**Appn No. 10/567,882**  
**Amdt date June 9, 2009**  
**Reply to Office action of February 9, 2009**

**Amendments to the Drawings:**

**REMARKS/ARGUMENTS**

Magnification Fig. 2 of Taubmann (reference signs added)

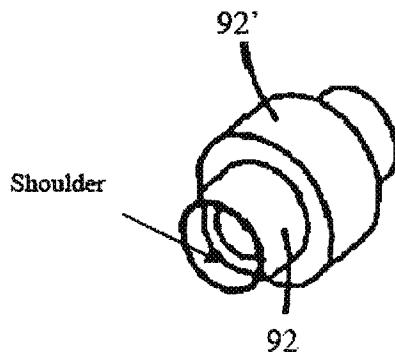
Referring to Fig. 2, Taubmann discloses a spindle nut 92 that has an opening. A magnification of the spindle nut 92 as shown in Fig. 2 of Taubmann is provided below and modified by Applicants to include reference numbers and text. As shown in Fig. 2 of Taubmann, the internal opening does not have a constant diameter, but rather has a shoulder on the inside of the spindle nut. This shoulder indicates that the diameter of the internal opening of the spindle nut is larger at the ends of the spindle nut in the axial direction. Furthermore, this shoulder appears to extend into subpart 92’.

A similar shoulder is visible also in Fig. 5 of Taubmann. In order for the spindle nut 92 of Taubmann to engage a threaded spindle and for the spindle to extend through the spindle nut, the internal toothing would have to be located axially between the shoulders. Furthermore, one

of ordinary skill in the art would not modify the spindle nut 92 of Taubmann in order to have internal toothing extending over a greater length so that the internal toothing extends axially into the at least one end section without external toothing, because the extended internal toothing would be incapable of engaging the threaded spindle due to the larger internal diameter of the end regions. Thus, the inner thread of the spindle nut ends at the shoulders without extending into the end regions (i.e., regions with the larger inner diameter) of the spindle nut 92.

FIG 2

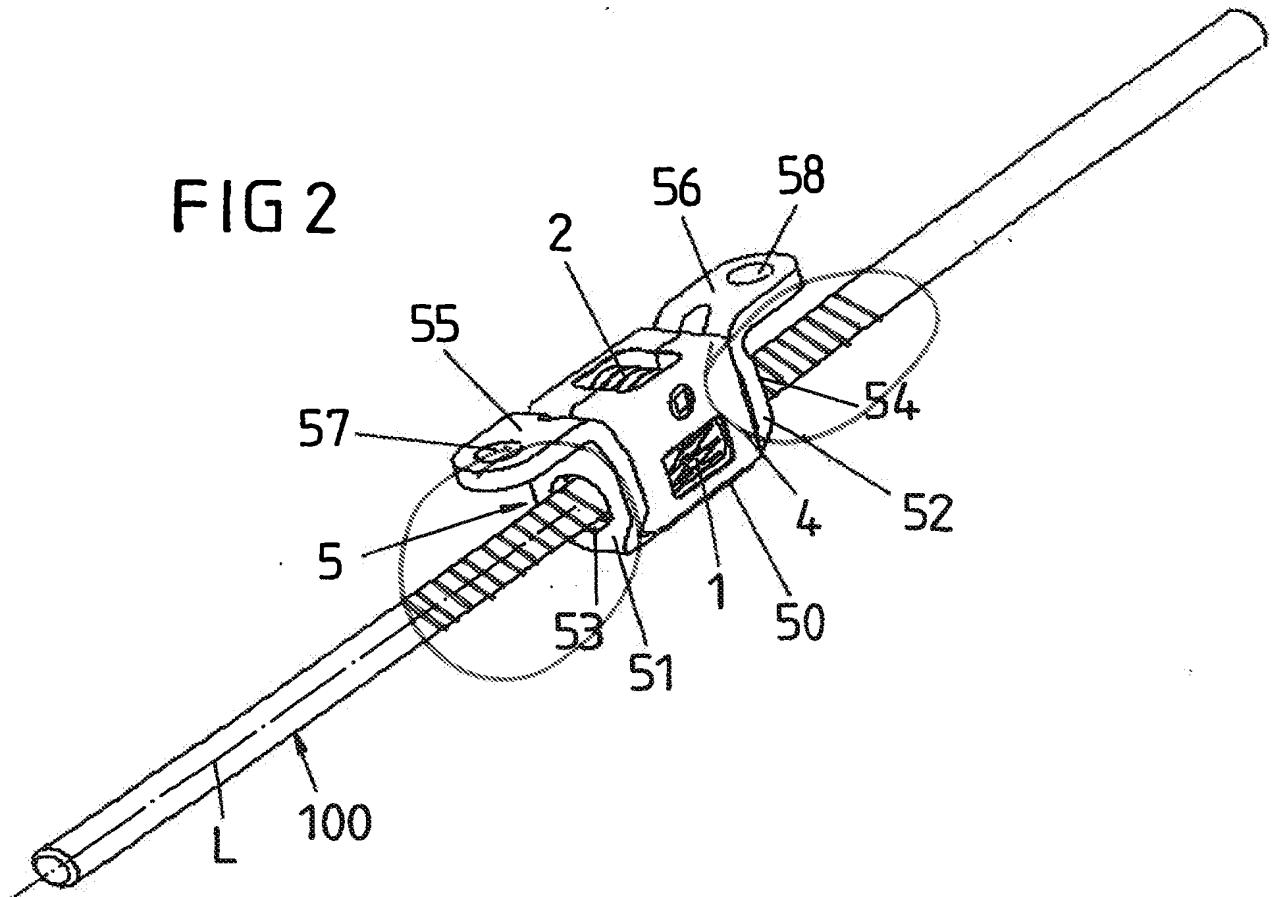
The attached sheet of drawings includes changes to FIG. 2 . This sheet, which includes FIGS. 2 and 3, replaces the original sheet including FIGS. 2 and 3.

The drawings have been objected to under 37 CFR 1.83(a). With respect to the drawings not showing the "indentation" as recited in claim 28, Applicants have canceled claim 28. With respect to the drawings not showing "the threaded spindle" as recited in claim 1, Applicants have amended FIG. 2 to show threading on a portion of the spindle 100. Applicants request withdrawal of the objection to the drawings.
